Dear members of the Plan Commission,

Members of Friends of Starkweather Creek have been meeting with city Planning staff for the past year to discuss the Pumpkin Hollow Neighborhood Development Plan. Overall, we feel this plan is fairly good, but we still have some concerns. This letter first sets out some general comments and then lists some specific text changes we would like in the plan.

Map 6: Land Use and Street Plan

Pumpkin Hollow Neighborhood Development Plan
October 2007

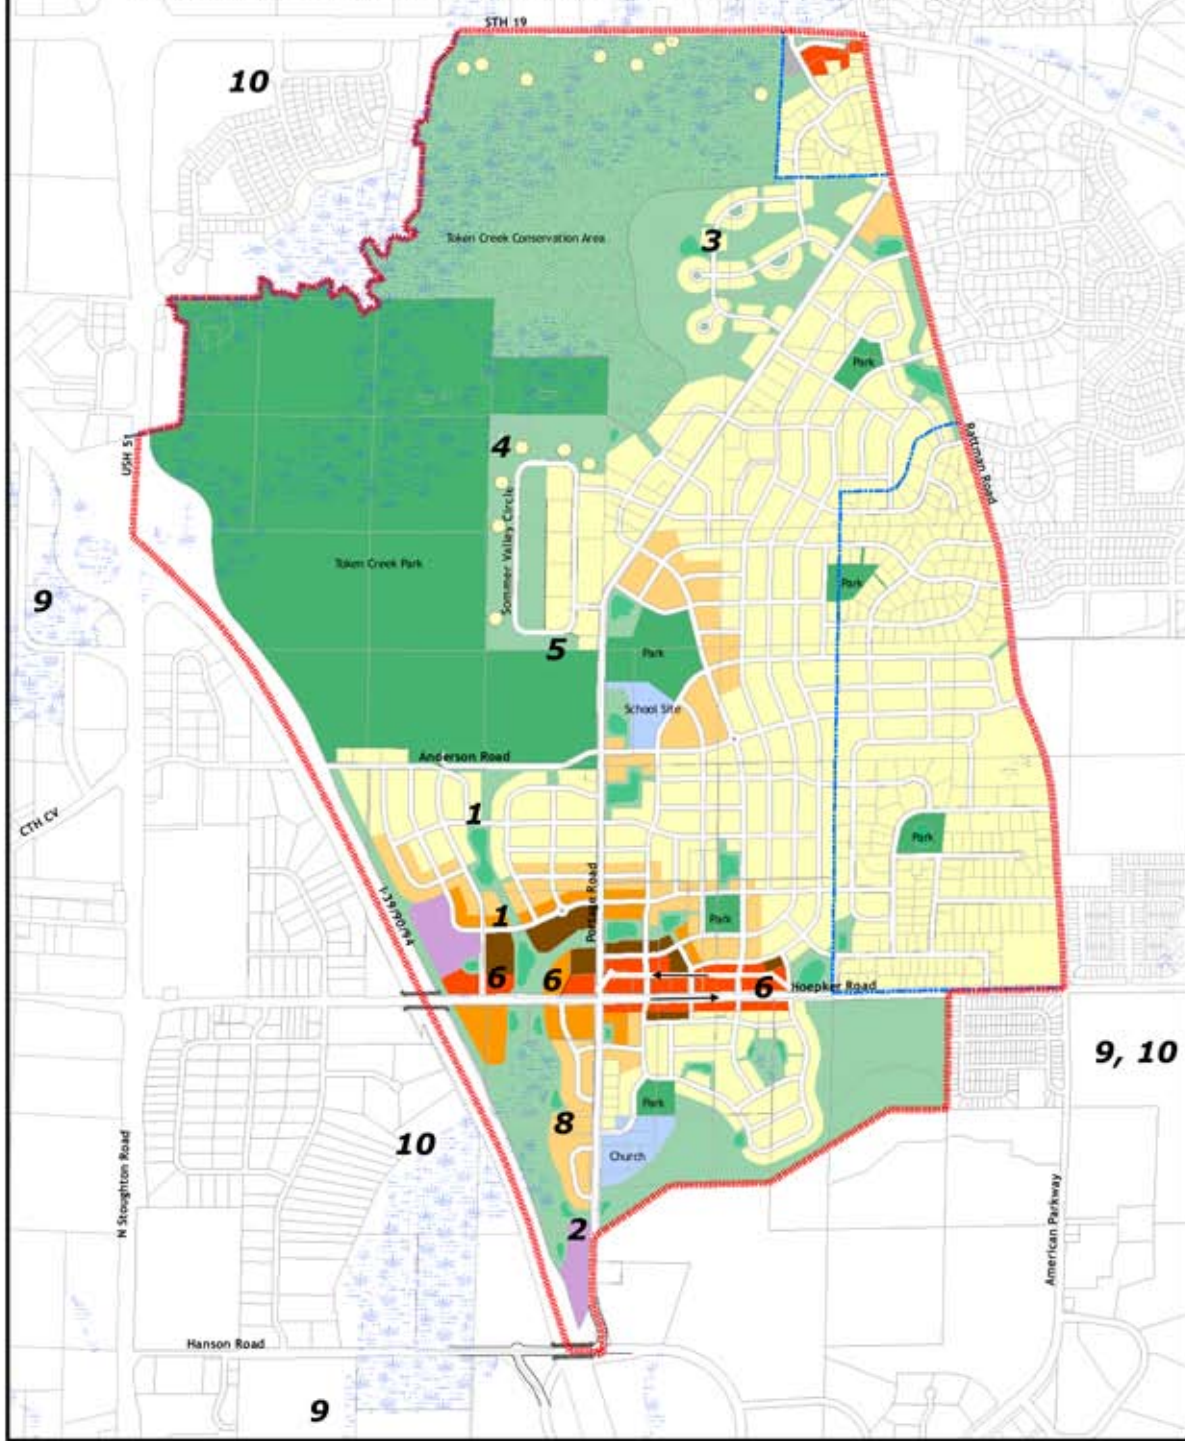
There are some "pinch points" where the Plan shows corridors as narrow as 70 feet. (See Map 6). We would like to see these bottlenecks removed to create continuous corridors as wide as possible.

We have included a copy of Map 6 marked with the locations of the specific comments below.

1. Please widen the creek buffer on the Starkweather branch between Hoepker and Anderson roads. The map shows the corridor as narrow as 80 feet total, minus a 10-15 foot wide bike path (or just 30 feet on either side of the creek). This corridor should be more wild and vegetated than just a drainage ditch or mowed swale.
2. There is a spot that a branch of Starkweather crosses Portage Rd south of Hoepker where the buffer is also too narrow. Please widen it as above to eliminate this bottleneck.
3. There is a spot where a coldwater tributary of Token Creek crosses a future subdivision road, west of Portage Rd, where the buffer is also too narrow. Please widen it as above to eliminate this bottleneck.

4. Sommer Valley Circle is surrounded by Token Creek Park and is very close to Token Creek wetlands. We disagree with the Plan recommendations (page 31) that would allow one additional subdivision of each parcel. Instead, the properties on the west and north side of the subdivision should be left as they are. Additional subdivision could be allowed in the rest of the parcels.

5. It may be desirable to provide pedestrian access to Token Creek Park from the southern end of Sommer Valley Circle, depending on the future site of the park entrance.

6. To reduce the impact of the neighborhood center on Starkweather Creek (see above), we suggest moving the high-density development east along Hoepker Road. Splitting Hoepker Road into two one-way pair streets here (as in the Pioneer neighborhood) would slow traffic and help create the feeling of an urban pedestrian friendly “downtown” center.

A different option would be to move the neighborhood center near the corner of Hoepker and American Family Parkway.

8. A street connection between two loop streets west of Portage and south of Hoepker would create better neighborhood connectivity instead of isolated developments.
